PROJECT ADDRESS: 822 Windsor Rd Rouse Hill, NSW 2155

FOR SECTION 96 APPLICATION

STAGES 1 & 6 ADAPTABLE UNITS DET

3 Proposed Modifications

STAGE 2 FLOOR PLANS

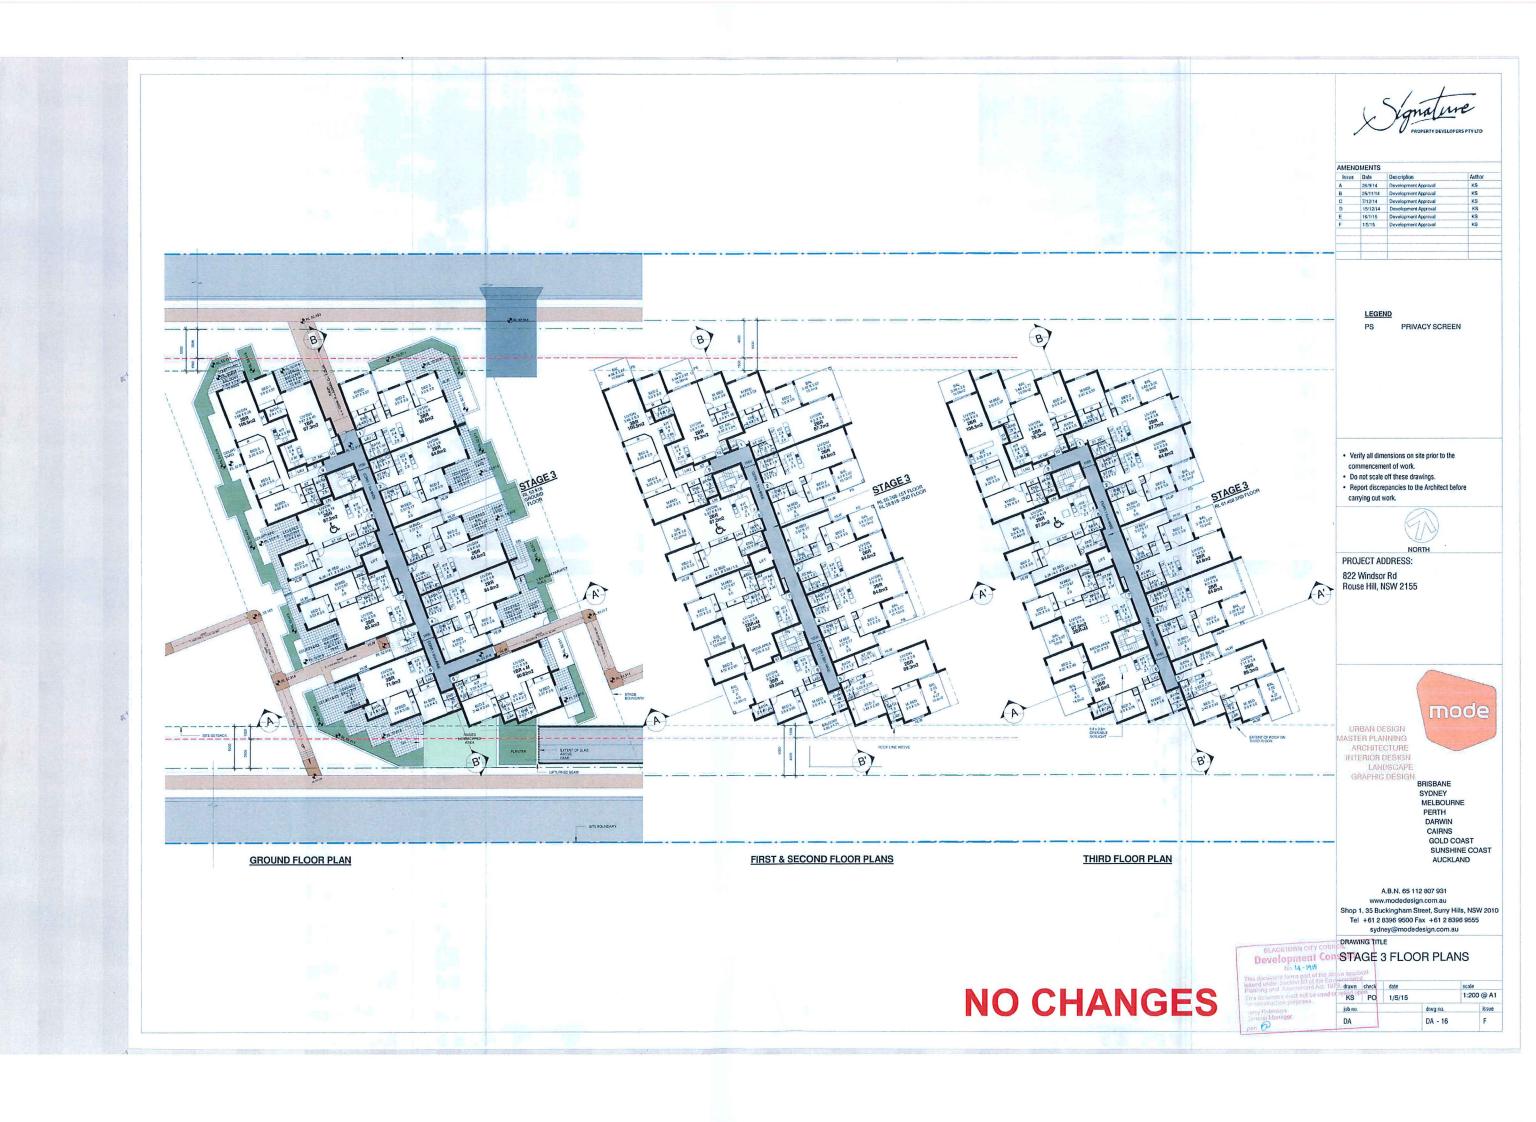
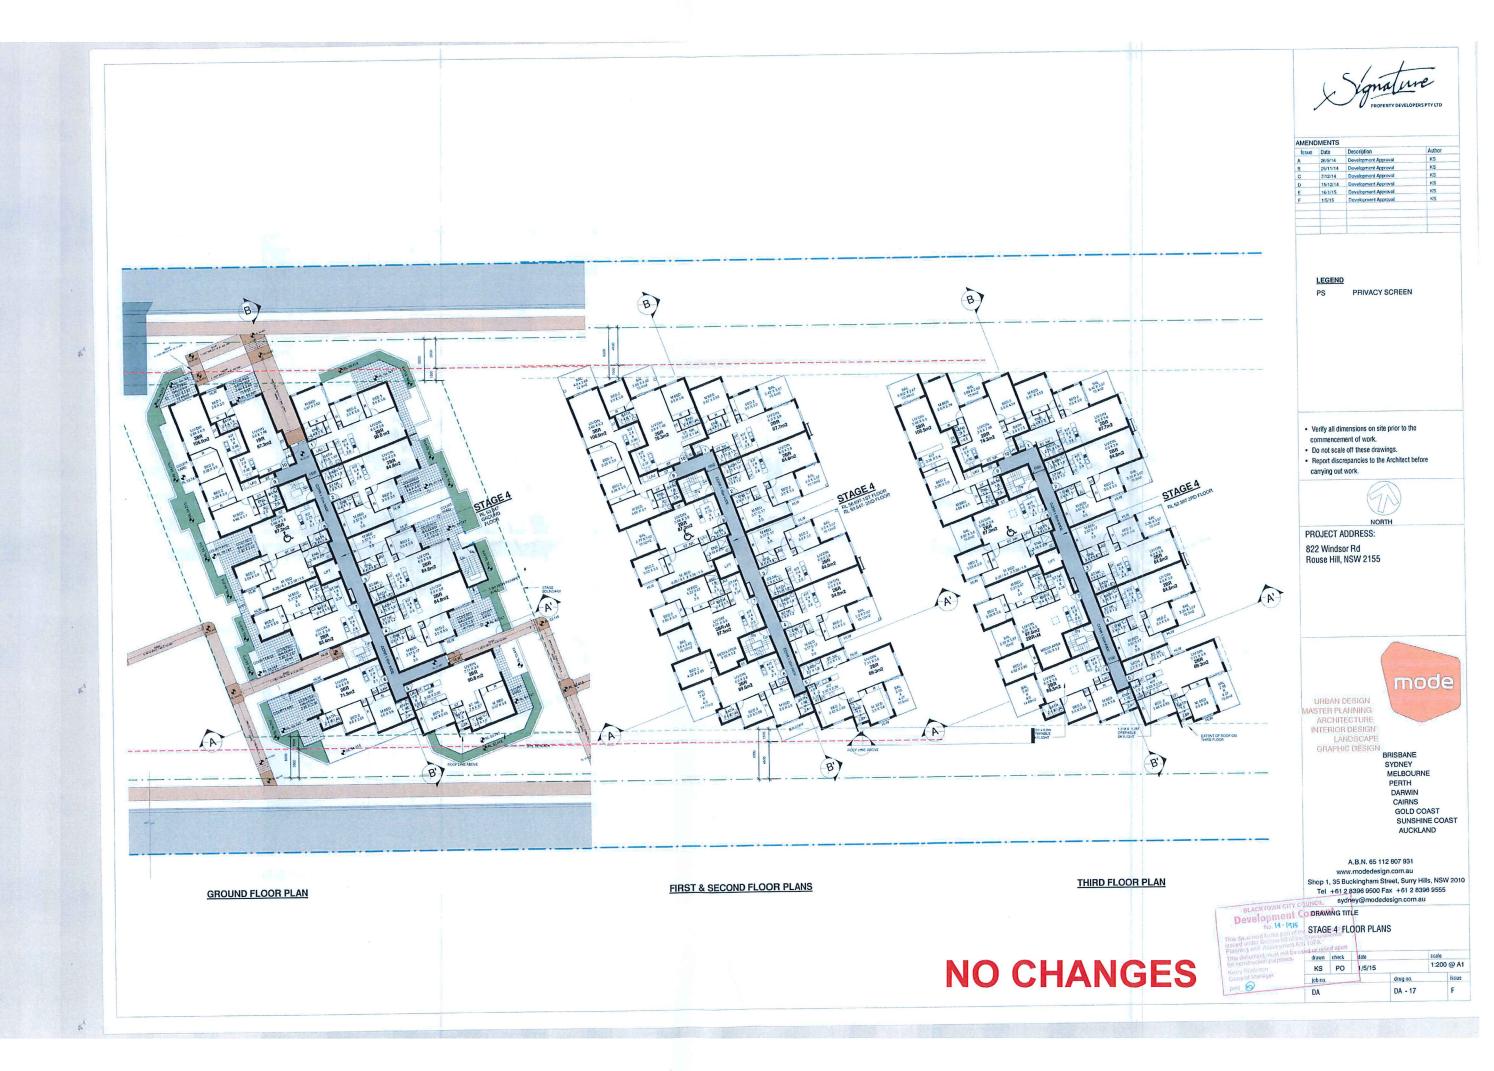
NO CHANGES

Development STAGE 5 FLOOR PLANS

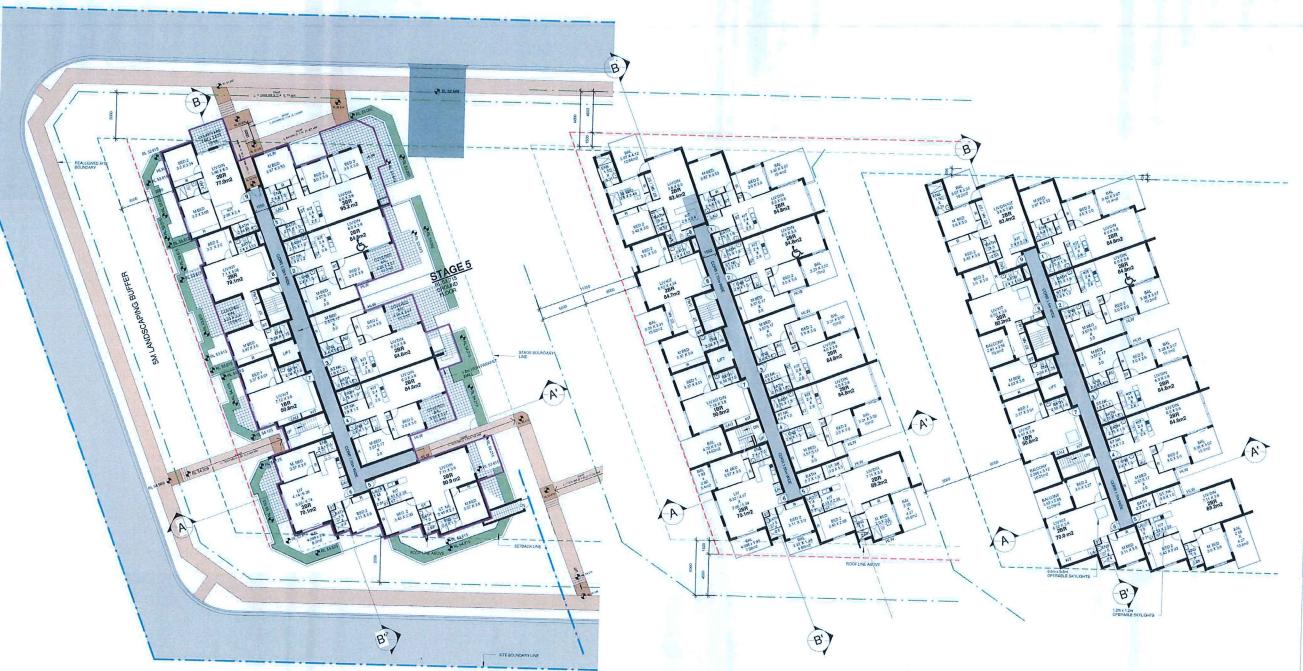
NO CHANGES

TOWN cisydney@modedesign.com.au Developawing tiftensent STAGES 2 & 3 ELEVATIONS scale 1:200 @ A1 on KS PO 11/6/15 D

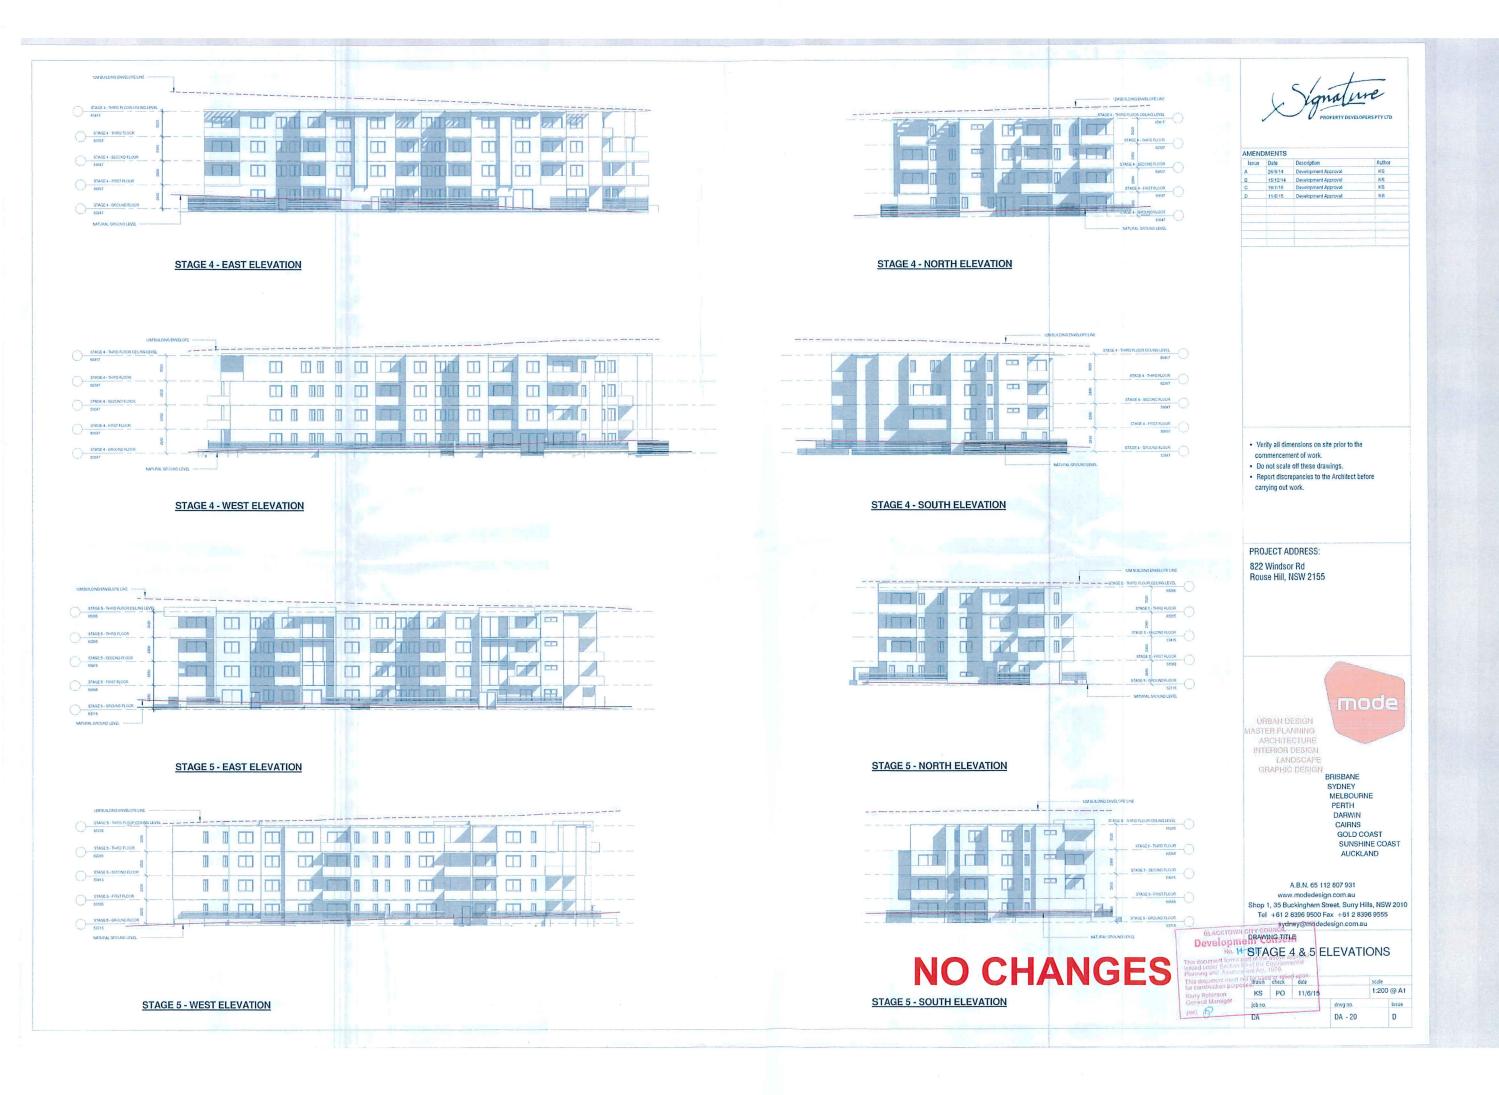
9. Façade elements	1 & 6	New façade treatment to be introduced including fenestration (windows/doors); balconies; louvre panels; material and external finishes and colours; balcony surround framing and balustrades; skillion roof element above balconies deleted; materials and finishes boards to be submitted.

25. Sun Control Systems	1 & 6	Active and passive sun control systems added to north facades to aid in improving amenity to units.
26. Privacy Screens	1 & 6	Privacy screens added to Stage 1 north balconies to provide additional privacy and comfort.

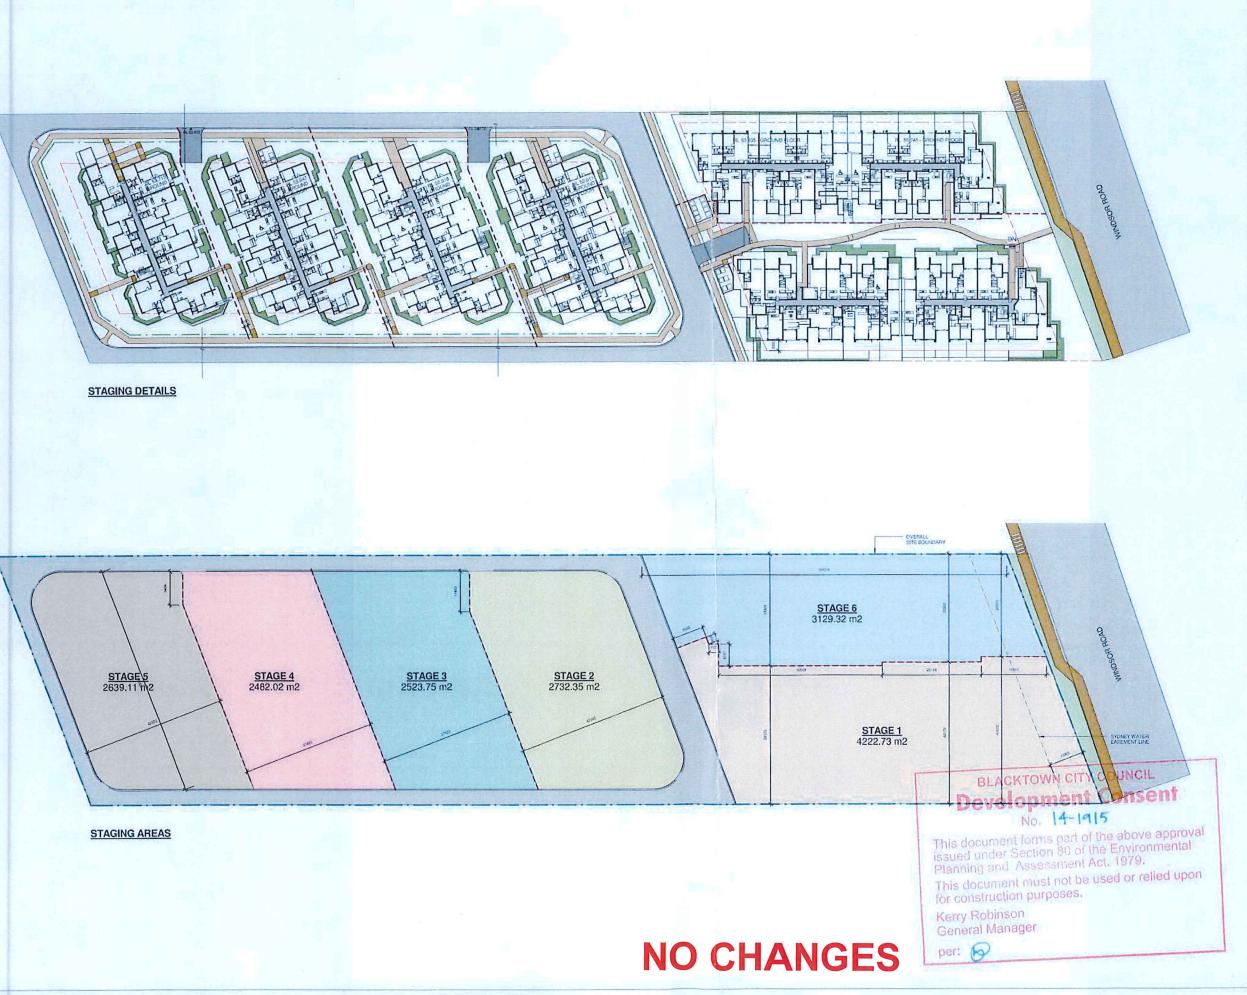
12. Adaptable units	1 & 6	Number of adaptable units reviewed and revised to comply with the Australian Standards.
13. Carpark	1 & 6	Parking numbers revised to comply with proposed unit mix and increased to 189 spaces comprising 162 residential spaces and 27 visitors (including adaptable spaces constructed over 2 levels. Refer to supplementary traffic and parking report for specific details.
